CITY OF KELOWNA

MEMORANDUM

File No.: Z20-0081

Subject: 605 Gerstmar Rd RU1 to RU2

SKETCH PLAN OF PROPOSED SUBDIVISION OF LOT 5
SECTION 22 TOWNSHIP 26 OSOYOOS DIVISION YALE DISTRICT PLAN 19913

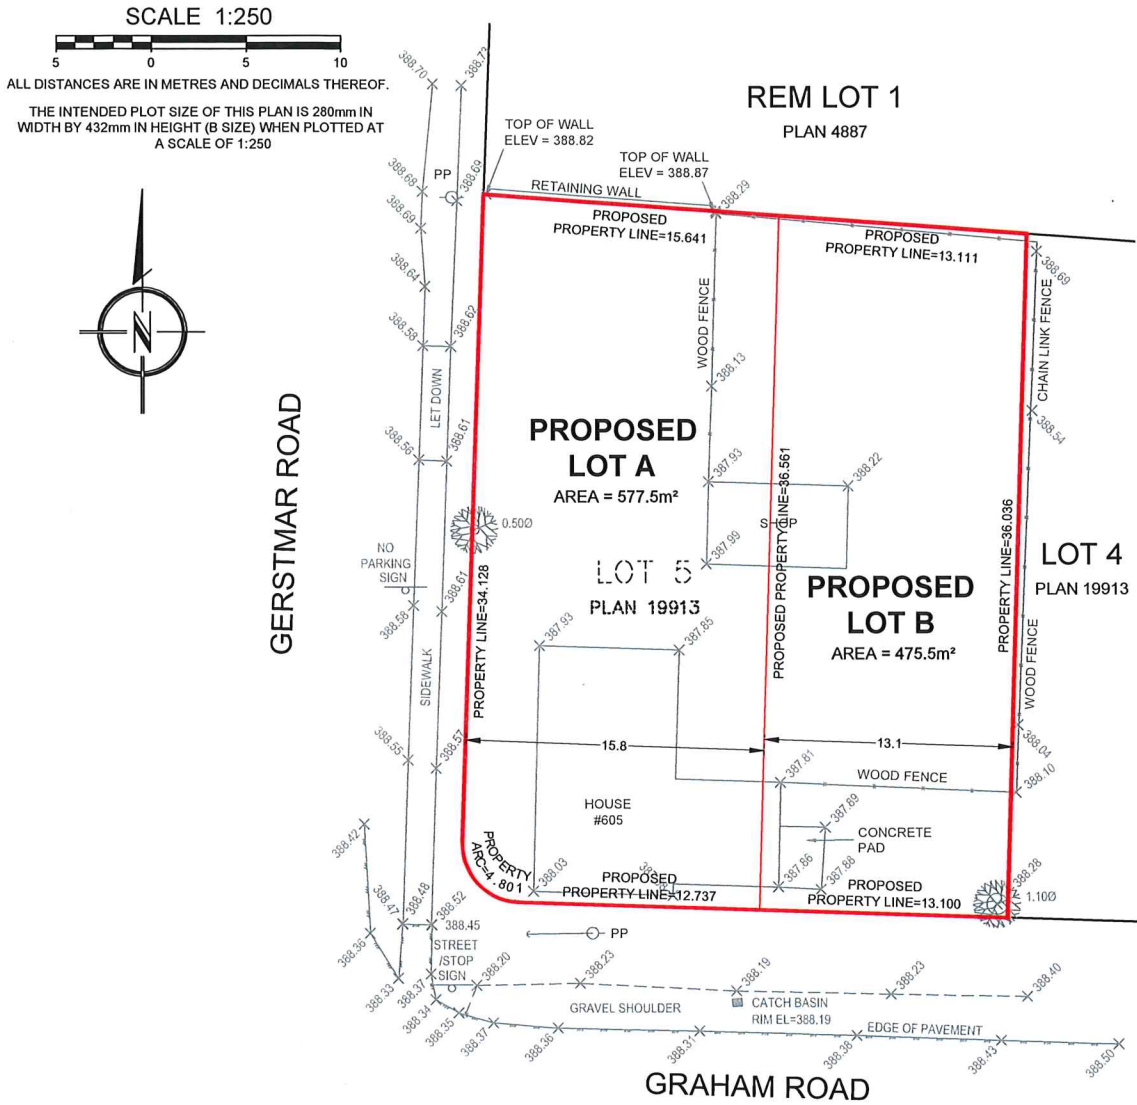
The Development Engineering Department has the following comments and requirements associated with this application to rezone the subject property from RU1 (Large-lot housing) to RU2 (Medium-lot housing) to support a two-lot subdivision. The road and utility upgrading requirements outlined in this report will be a requirement of this development. The Development Engineering Technician for this project is Sarah Kelly.

- a) Each legal lot shall require only one individual sanitary service connection complete with an inspection chamber (SS-S7) and Brooks Box (SS-S9), to be installed at the applicant's cost.
- b) The existing lot is currently serviced with a 100-mm sanitary service. If the existing service connection is to remain it will be required to be completed with an inspection chamber and Brooks box.

- a) Gerstmar Rd is classified as a Major Collector under the City of Kelowna's 20-Year Major Road Network. The section of Gerstmar Rd must be upgraded to a collector standard along the full frontage of this proposed development, including sidewalk, curb and gutter, pavement removal and replacement, boulevard landscaping, drainage infrastructure (catch basins, perforated storm pipe, and drywell), and re-location or adjustment of utility appurtenances if required to accommodate the upgrading construction. The road cross section to be used is SS-R6.
NOTE: Pipe and drywell inverts to consider eventual connection to existing storm main at Gerstmar Rd and Tataryn Rd – DWG A-2482-4.

- c) Graham Rd must be upgraded to a local standard along the full frontage of this proposed development including curb and gutter, pavement removal and replacement, boulevard landscaping and re-location or adjustment of utility appurtenances if required to accommodate the upgrading construction. The existing catch basin is to be relocated to the new gutter line. The road cross section to be used is a modified SS-R3.
